BIENNIAL REPORT 113TH CONGRESS

AMERICANS WITH DISABILITIES ACT INSPECTIONS RELATING TO PUBLIC SERVICES AND ACCOMMODATIONS

OCTOBER 2016

Figure 3. A curb ramp with a wide crack/gap located on the southeast side of the Capitol Building.

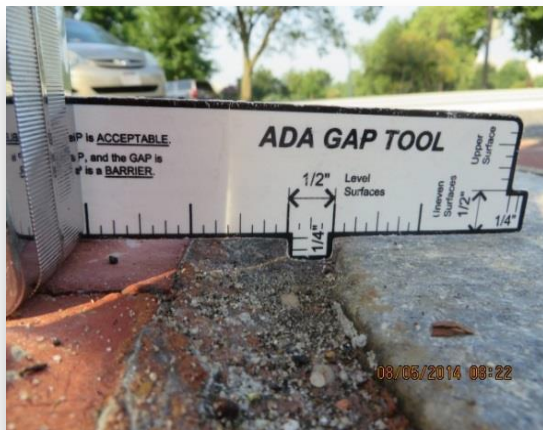
When there is an abrupt change in level between the curb ramp and the adjoining pathway, wheelchairs may become unstable.

Deep or wide cracks and gaps can trap the small steering wheels on wheelchairs or the even smaller anti-tip wheels on motorized wheelchairs and cause stability and control problems for the user.

Figure 8. AOC Accessible Pathways Map

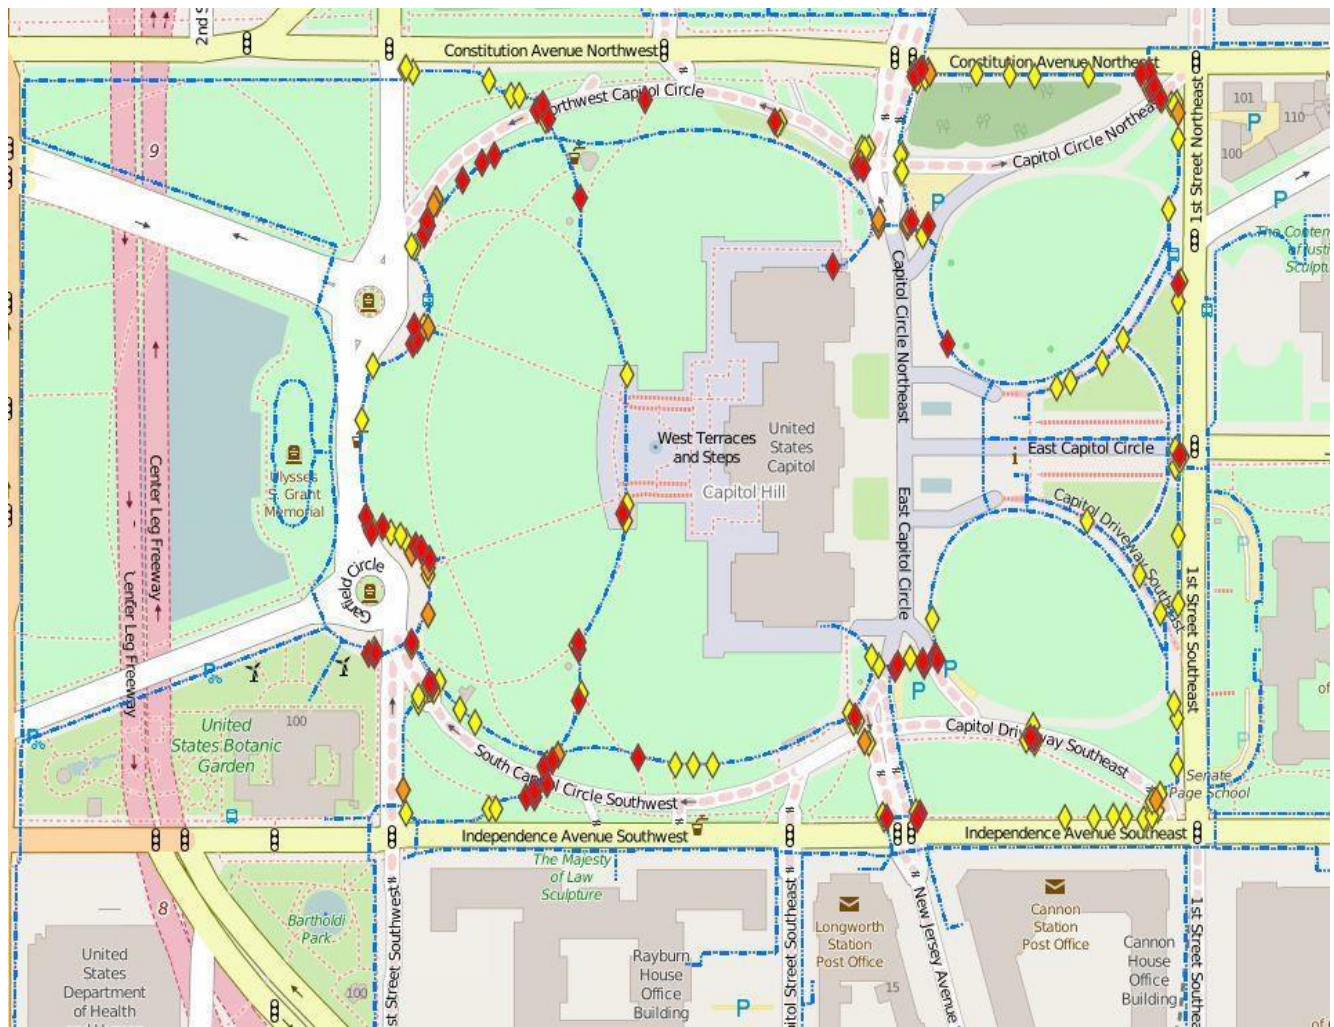
Beginning in the 112th Congress, the AOC began using an accessible pathways map to further aid in prioritizing the identified barriers for abatement. This accessible pathways map highlights the accessible pathway from each of the public transportation drop-off points to each of the buildings on the Capitol Hill campus. The AOC plots the barriers that fall on this pathway on the map. Barriers on the accessible pathway are given additional priority consideration for abatement.

The AOC accessible pathways map for the 113th Congress is reproduced below:
